Agenda
Village of Glen Ellyn
Special Village Board Workshop
Monday, September 11, 2023
6:00 PM
Glen Ellyn Civic Center, Room 301

Glen Ellyn Metra Station and Multimodal Access Improvements Project (Engineer Daubert)

Value Engineering Proposal No. 2, 3, 4, and 24 - Station Square Footage

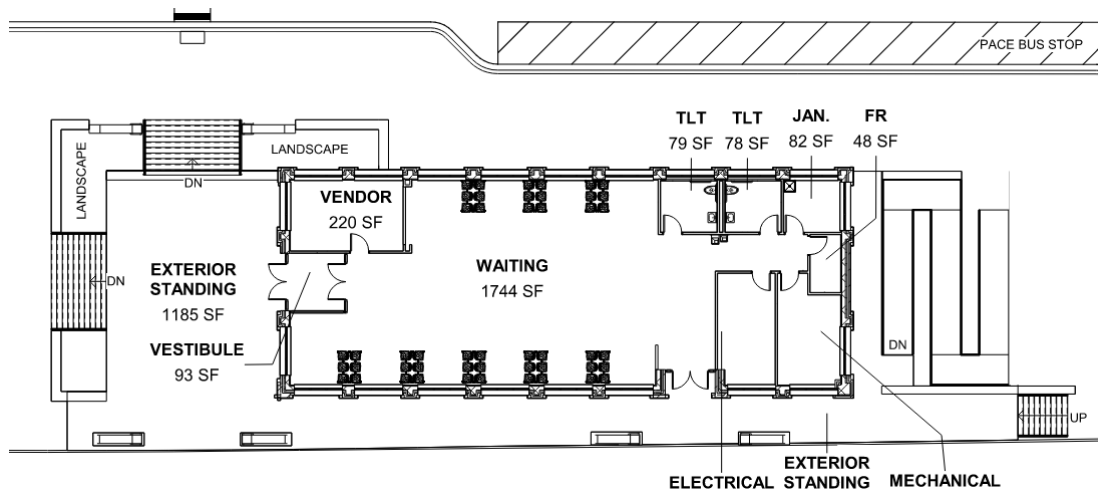
Based on the VE workshop, proposed revisions to the station design concept include reducing station size to better align with new Metra standards, as published post-pandemic in 2022. This cost reduction is based on a simplified footprint and maintaining the same general architectural style. The revised conceptual floor plan meets the new Metra standards for standing, seating, heated, and covered waiting areas, which are based on current 20-year ridership projections from Metra to accommodate future growth. It also accommodates a small vendor area inside the station. This design reduces the footprint by approximately 600 SF, an increase from the existing station of approximately 1,000 SF. It reduces the cost from previous estimates by approximately \$1.5M (before application of mark-ups, contingency, and escalation) and \$2.5M after application of markups. Refer to the floor plan diagrams below.

Previous conceptual floor plan – approx. 3,600 SF

Revised conceptual floor plan – approx. 3,000 SF

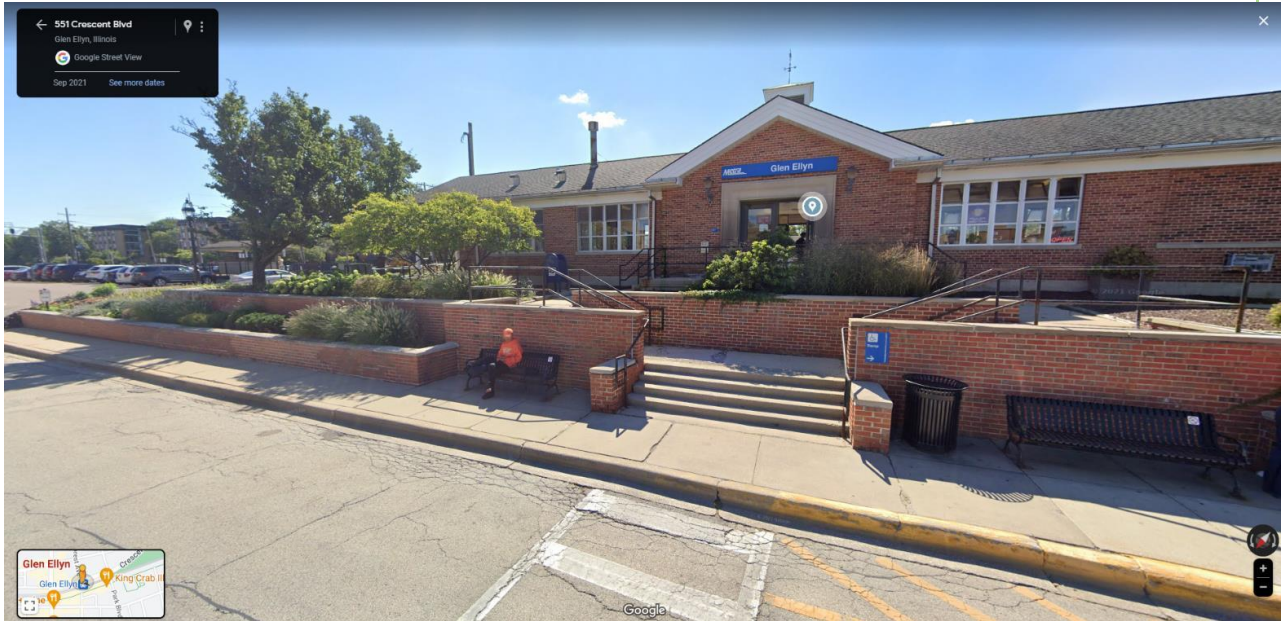
Notice that the retaining walls, while nice materials and landscaping, make access to the station building more difficult, less porous. The walls, narrow sidewalk, and roadway act as a divider from the businesses and activity on the north side of the road.

A view of the existing station entrance from Crescent Boulevard. (Source: Google Streetview)

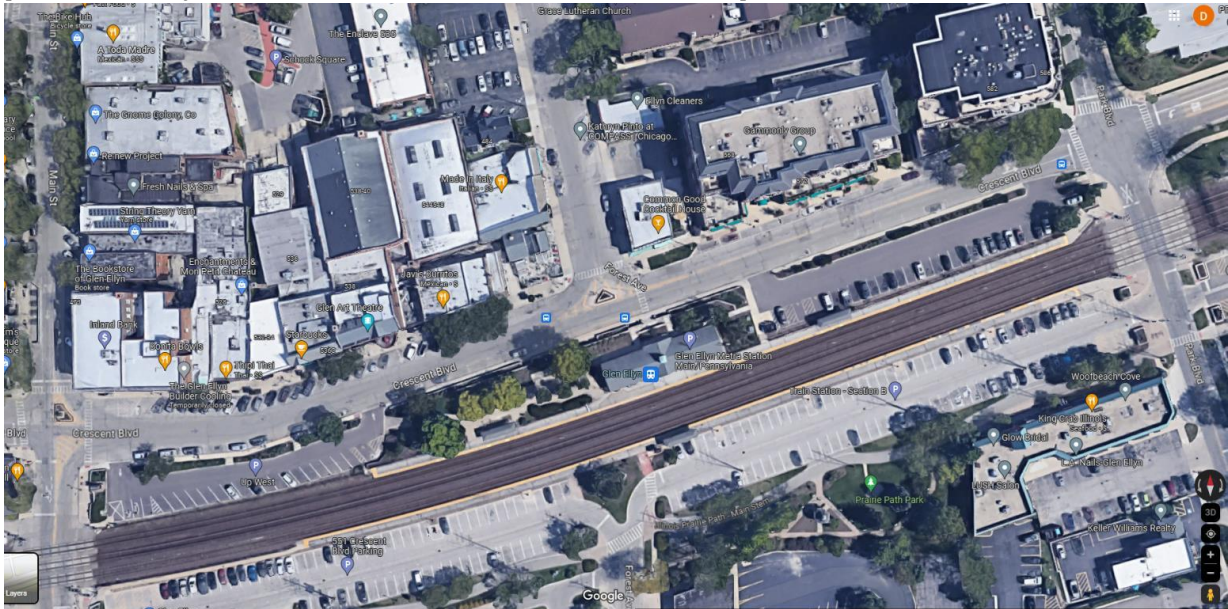
Note that while the existing stairway is a nice aesthetic design (with landscaping), it adds friction between station and Crescent. The sidewalk along Crescent is too narrow to be inviting.

The station entrance based on a concept rendering.

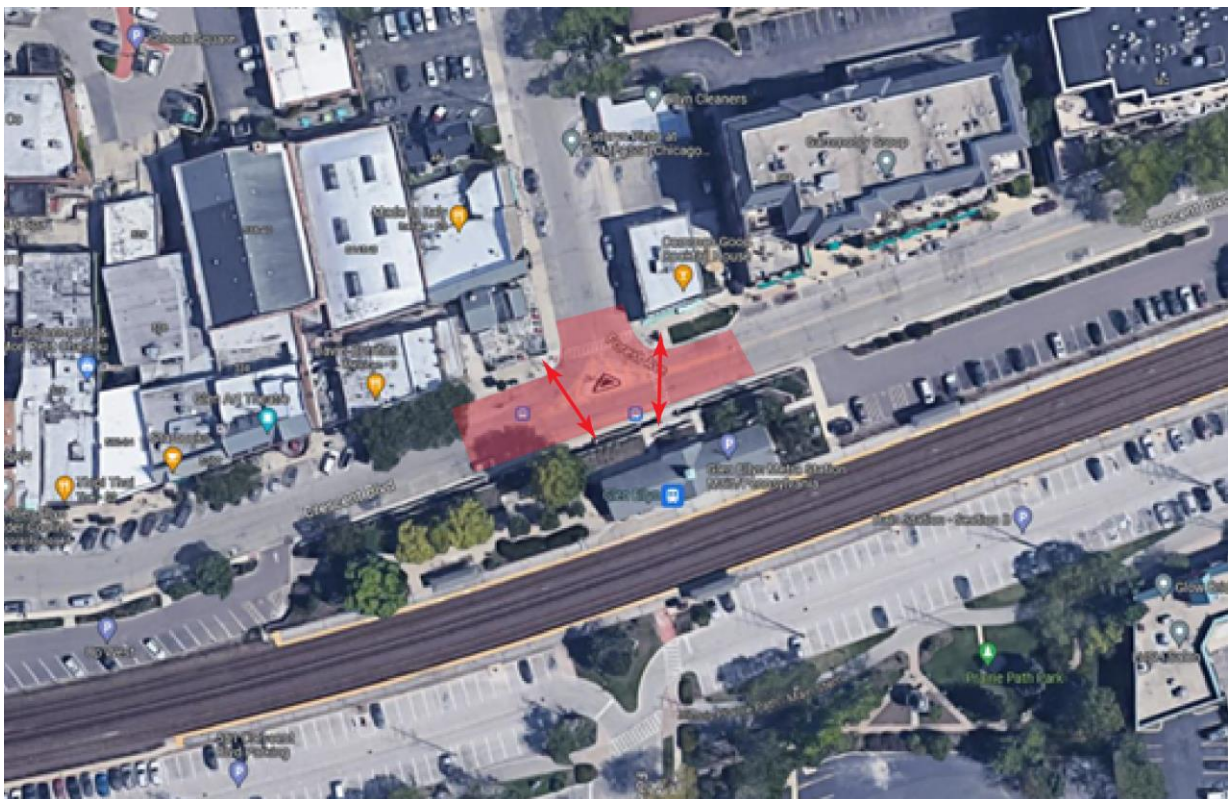
While some aspects of the rendering may not reflect the 10% conceptual design, the rendering does appear to still include a narrow sidewalk between a wall and traffic. (Actual sidewalk width in the design is 13 feet.) This design, while aesthetically pleasing does little to better integrate uses and function. The placement of the stairs from the station exit somewhat directs people out into the street. (There is not a connection to

“place” when exiting the station building.) Additionally, the roadway layout and material does not equalize pedestrians, bicyclists, and traffic, and does not create a sense of place.

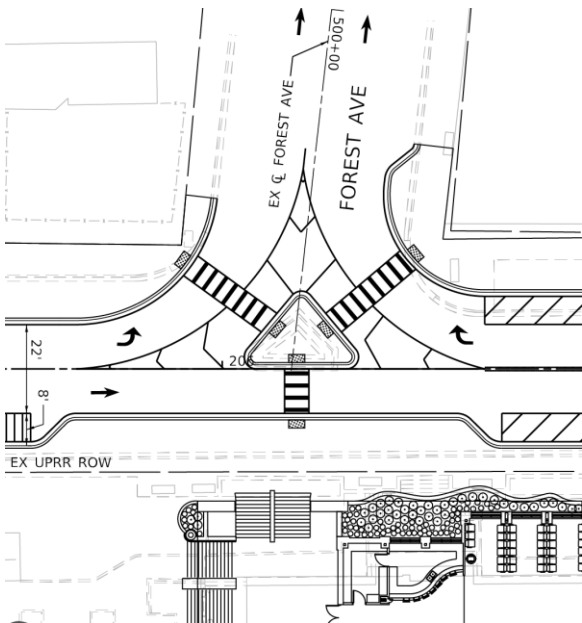
Alternate Design: Move main entrance to the west near Forest Avenue as to capitalize on the stairs at that location as well as the ramps to the underpass and platform levels. The existing main entrance pictured above could in turn be eliminated. See attached mark up of site plan for some rough thoughts. Planters could be utilized to frame the stairway entrance to the depot on the street side. A ramp leading to the main entrance door would be challenging to keep along Crescent Boulevard given the grade differential between Crescent and the Depot Floor which is 7 feet. The ramp would be on the order of 100' long and take up significant real estate along the north side of the building.

The recommendation from the VE team is to move the entry stairs to the west arch, aligned with Forest Avenue. This is depicted in the plan view to the right. Unless this move requires examination of alternatives by multiple parties, the schedule change should be minor.

Note that this change works in conjunction with other VE ideas #7 and #22. This change also would allow simplification of the station building layout (not shown), further reducing cost.

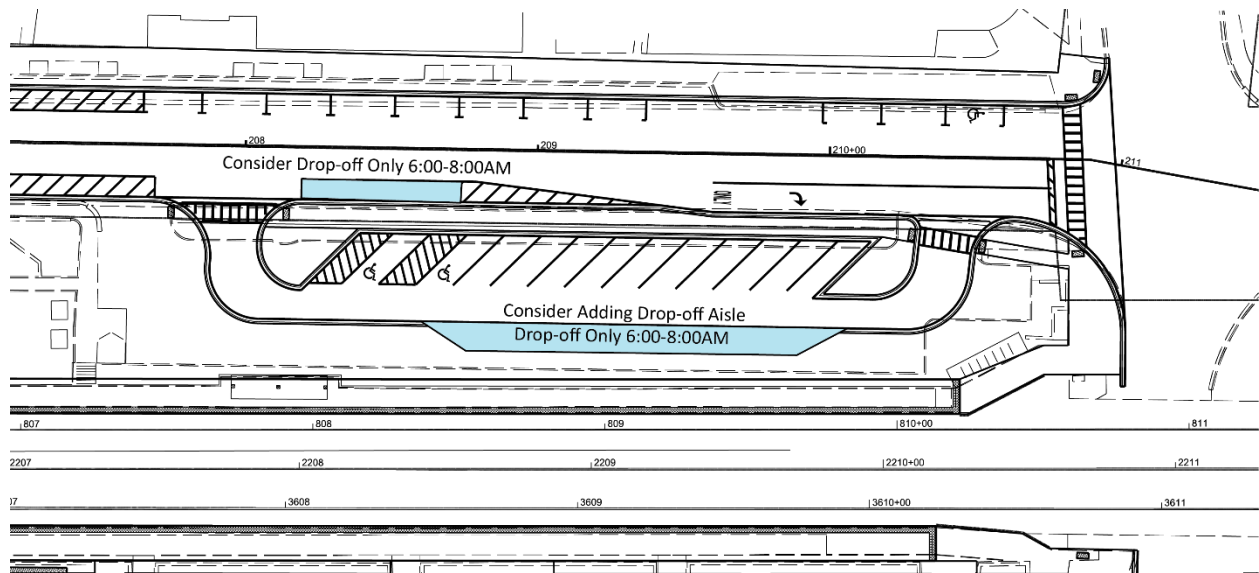
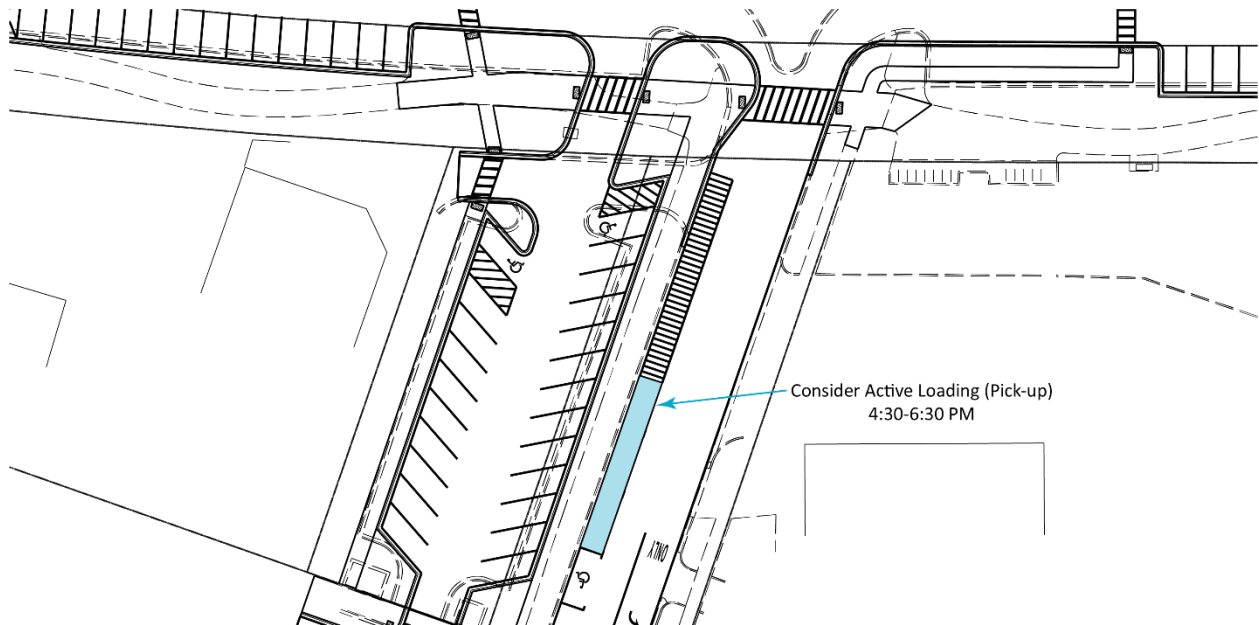
If the curb-side drop-off space directly at the proposed plaza begins to overflow (which may present a pedestrian crossing or traffic flow issue), consider (a) time restrictions (e.g., active unloading only), and/or (b) expansion of drop-off curb space to the area shown in blue.

Again, if the drop-off space to the west overflows, consider (a) adding more space curbside (that reverts to parking after 8:00 AM), and/or (b) creating a curb inset within the parking lot. This latter space may be more popular for those who need more time to unload. Also, the platform could be accessed from the east end rather than from the stairs at the station.

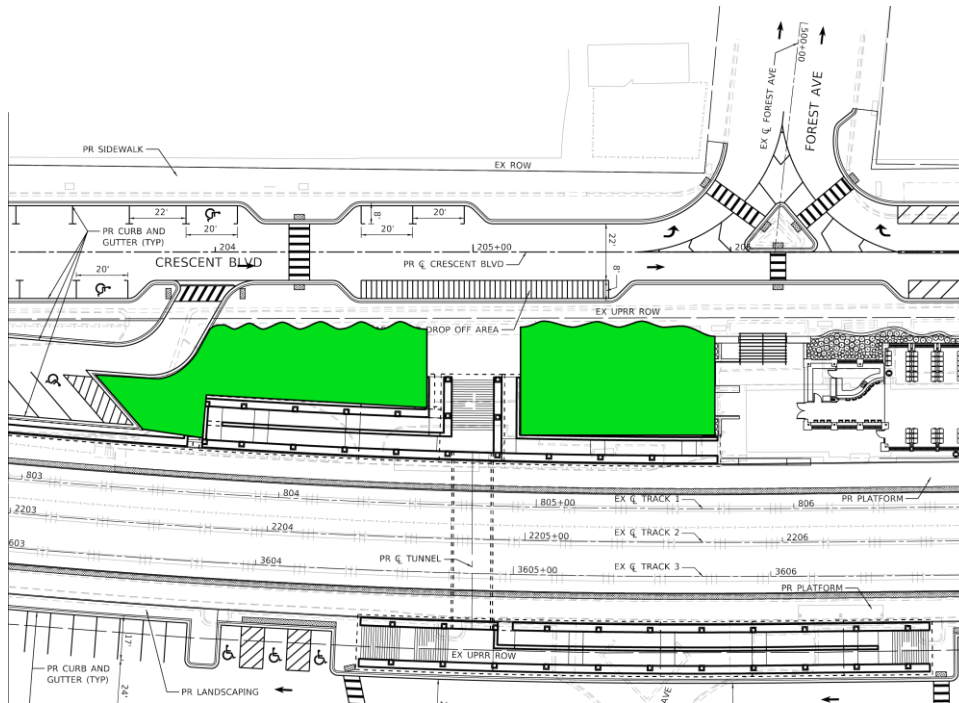
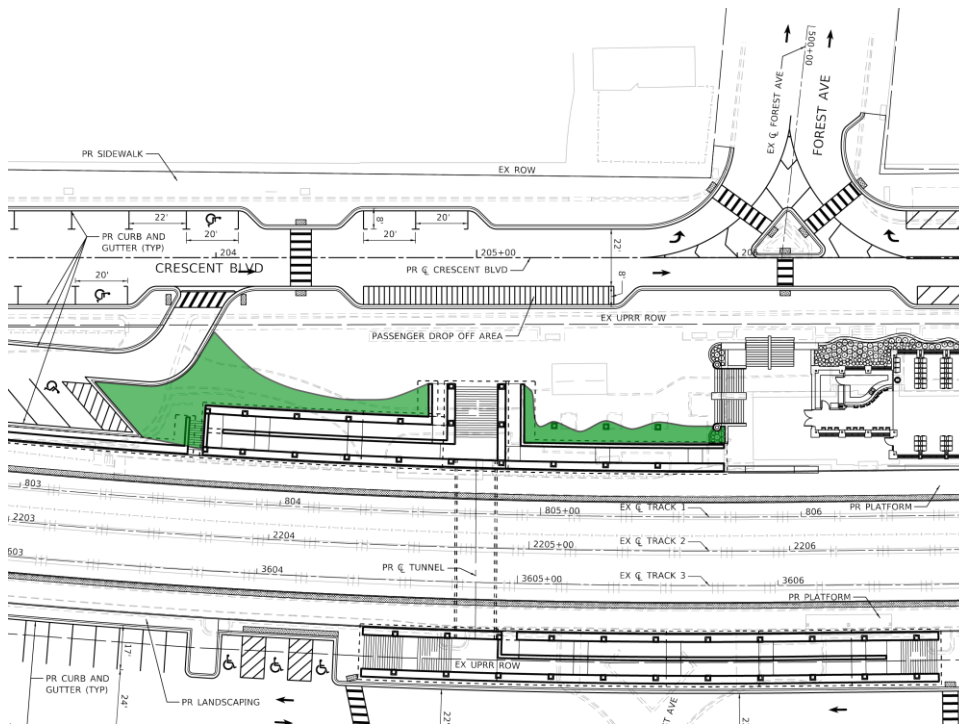
Discussion:	At least one Board Member expressed desire of eliminating the plaza given the US Bank site conversion to a park. Not sure they're one in the same. We could also look at still mass grading to keep the open feeling but creating a green/landscaped area in lieu of pavement. That could still yield a significant savings of say \$300K.
Summary:	Estimated cost increase in Design Phase: Additional retaining wall design and grading plan costs say \$30K. Estimated capital cost change: Significant savings could approach \$800K - \$1M. However, balancing a reduction in grading with the need for plaza elements (related to various project goals), a value of \$250K was used for the cost reduction. Estimated schedule change: Minor.
Review:	☐ Accept and include in project ☒ Further study needed ☐ Reject for this project

(Above) Depiction of minimization of excavation. The wavy planter wall is intended to duplicate the pattern of the planter to the east of Forest Avenue. The issue with this minimal case is that a “cavern” appearance is created from Crescent Boulevard. Additionally, no plaza is created.

(Below) Depiction of a balanced approach. By constructing a portion of the plaza (with associated excavation), some cost savings is realized, but the openness of the plaza creates the desired interface with Crescent Boulevard. This is the recommended option.

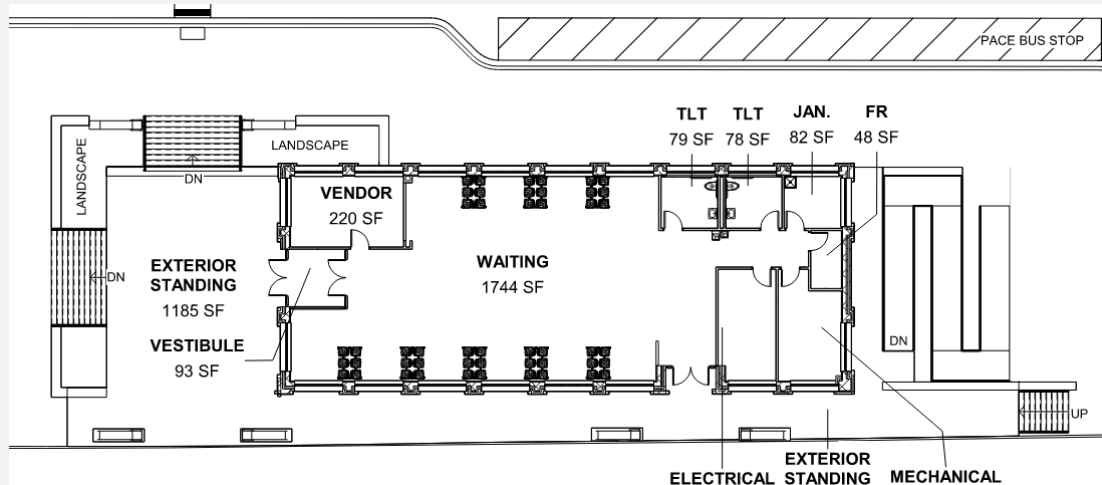
Previous conceptual station layout – Approx. 3,600 SF

Conceptual reduced station layout – Approx 3,000 SF

- Alignment with new Metra Standards
 - Waiting area requirements published post-pandemic in 2022, using current growth projections from Metra
 - Reduction of 600 SF and a simplified footprint in the same architectural style result in \$2.5M savings
- Improve pedestrian interface at Crescent Boulevard / Forest Ave
 - Align entrance with Forest Ave
 - Improved access from Pace Bus stop
